# Access Compliance Report

## Public Rights-of-Way

### (Curb Ramps)

Intersection ID: N/A	Main Street: SHOPTON_RD	Cross Street: ROCK_ISLAND_RD	Location: S
ADA ID: 0EBCCFC290AA	Ramp Type: BlendTrans1	Initial Pass/Fail: Fail	Overall Compliance: No
Codes/Mitigation Info/Possible Solution		Field Measurements/Component Compliance	
Severity Score: 10

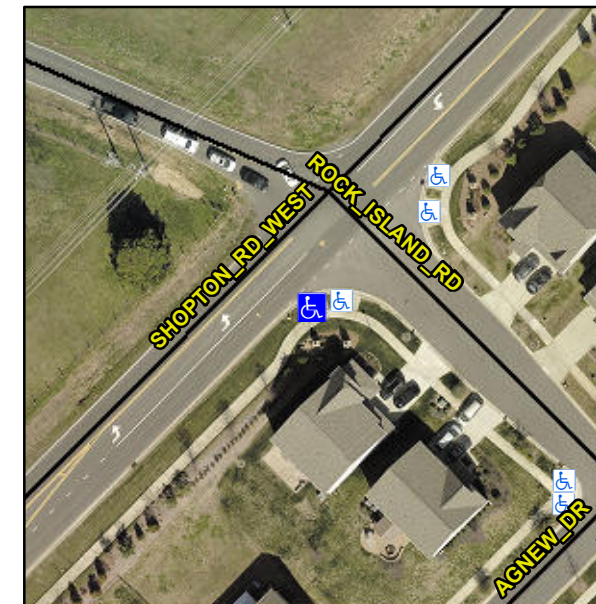
Compliance	Description	Data	Compliance	Description	Data
N/A	Ramp Length (in)	94.0	Yes	BlendTrans Slope (%)	3.9
No	Ramp Width (in)	45.5	No	BlendTrans XSlope (%)	2.2
N/A	Flare Type LT	N/A	N/A	Flare Type RT	N/A
N/A	Flare Slope LT (%)	N/A	N/A	Flare Slope RT (%)	N/A
N/A	Flare Traversable LT?	N/A	N/A	Flare Traversable RT?	N/A
N/A	Landing Length (in)	N/A	N/A	DWS Provided?	N/A
N/A	Landing Width (in)	N/A	N/A	DWS Contrast?	N/A
N/A	Landing Slope (%)	N/A	N/A	DWS Length (in)	N/A
N/A	Landing X Slope (%)	N/A	N/A	DWS Full Width?	N/A
N/A	Landing Curb? (Y/N)	N/A	N/A	DWS Offset (in)	N/A
N/A	Shared Landing?	N/A			
N/A	Gutter Ponding?	N/A	N/A	Gutter Slope (%)	N/A
N/A	Gutter Lip Ht (in)	N/A	N/A	Gutter X Slope (%)	N/A
N/A	Painted X Walk1?	No	N/A	Painted X Walk2?	N/A
	X Walk 1 Direction	To NW		X Walk 2 Direction	N/A
	X Walk 1 Width (in)	N/A		X Walk 2 Width (in)	N/A
	X Walk 1 Slope (%)	4.5		X Walk 2 Slope (%)	N/A
	X Walk 1 X Slope (%)	1.1		X Walk 2 X Slope (%)	N/A

N/A	Ramp inside XWalk1?	N/A	N/A	Ramp inside XWalk2?	N/A
	Road Slope (%)	1.1		Clear Space?	N/A
	Road X Slope (%)	4.5	N/A	Clear Space to XWalk (in)	N/A
N/A	Any Obstructions?	N/A	N/A	Storm Grate/Utility Hazard?	N/A
	Obstruction Type			Storm Grate/Utility Type	
		N/A			N/A
			Yes	Surface Condition? (G/P)	Good
			N/A	Curb Slope (%)	5.0

**Remove & Replace Curb Ramp With Two New Directional Ramps or Equivalent.**

**R304.5.1, R304.5.3**
